"DIMENSION®" 2000 AND "DIMENSION" CUSTOM PBXs SYSTEM DESCRIPTION

1.001 This addendum supplements Section 554-111-100, Issue 9. Place this pink sheet ahead of Page 1 of the section.

1.002 This addendum is issued for the following reasons:

Fig. 37.1—Voice Store and Forward Interface

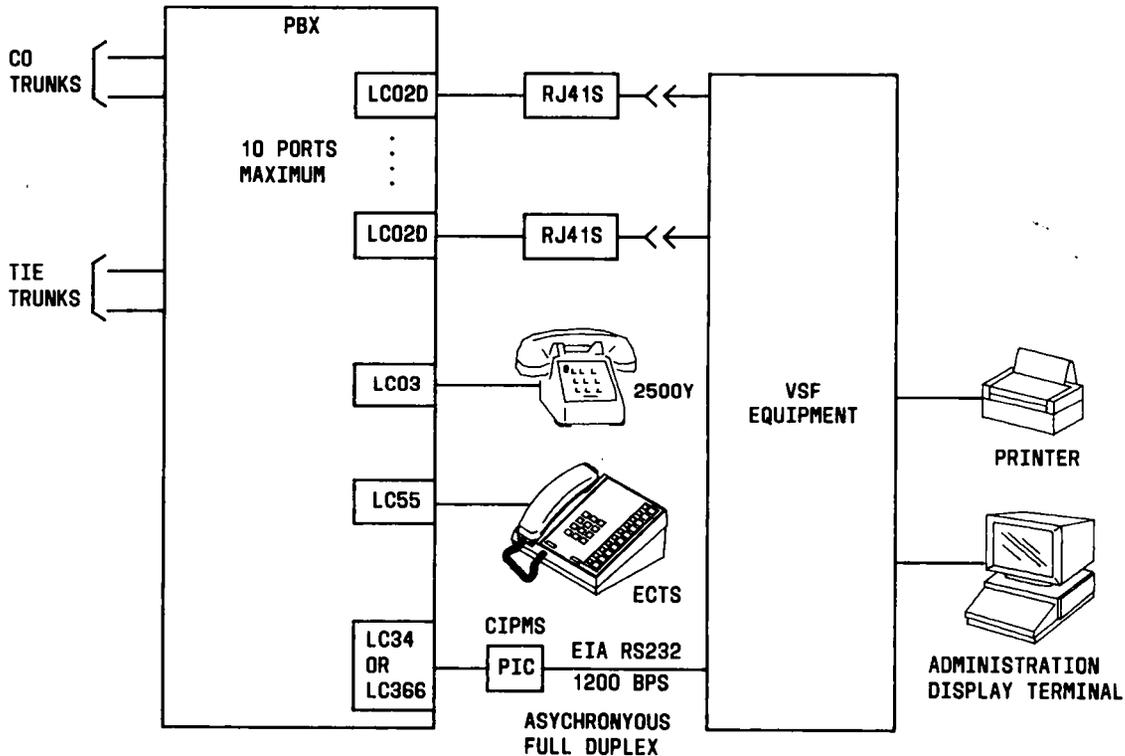
2.003 On Page 94, after paragraph 3.371 add the following new feature description.

3.371.2 Figure 37.1 illustrates the VSF interface.

Voice paths from the PBX are via LC02D circuit packs. An RJ41S jack is used as the interface point between PBX wiring from the LC02D and the VSF equipment. The Customer Interface for the Property Management System (CIPMS) feature is used as the mechanism by which a VSF subscriber is alerted concerning the presence of a message. The PIC shown can be located no more than 300 meters (1000 feet) from the VSF equipment without range extension. A maximum of four range extensions of 750 meters (2500 feet) each are permitted. The status inquiry time-out interval used for CIPMS between the PBX and VSF equipment is 6 minutes instead of the 10-second time-out used for the Property Management System interface to the PBX.
